**FIVE NATIONS ENERGY INC. (“FNEI”) RESPONSES TO INTERROGATORIES OF  
FORT ALBANY POWER CORPORATION (“FAPC”)**

FIGURE 1:

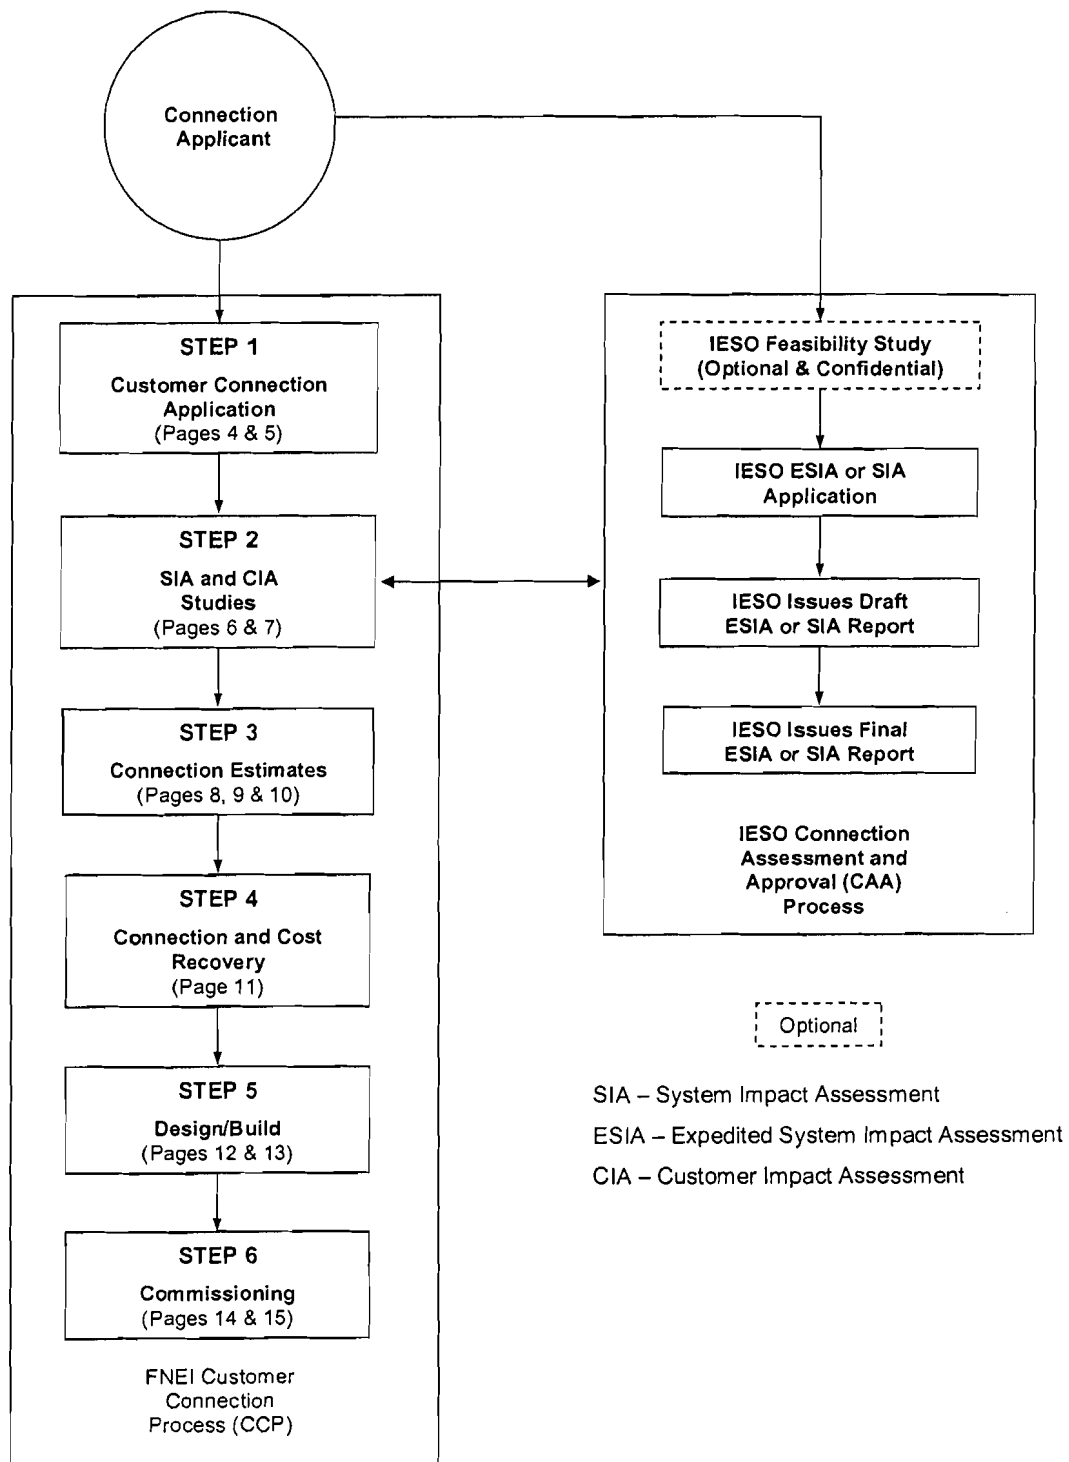
**Reference** CCP Pg 3 Figure 1 and 1.2.3

Please provide the attachment that was labelled as “Figure 1”. Please provide the item inserted at 1.2.3 named “FNEI Customer Connection Process (CCP)”. Please provide a legible copy of paragraph 1.2.3.

See attached Figure 1.

Section 1.2.3 states: FNEI and the Connection Applicant will meet to discuss the information contained in the Customer Connection Application Form, as outlined in section 1.1 above. FNEI will be prepared to discuss the transmission system (existing equipment, available capacity, other proposed connection projects) in the area of the proposed connection, to identify any issues related to the Connection Applicant’s proposal, and to provide the Connection Applicant with information on any pertinent transmission projects in the area that are part of FNEI’s transmission plans (refer to Appendix 3 in this document).
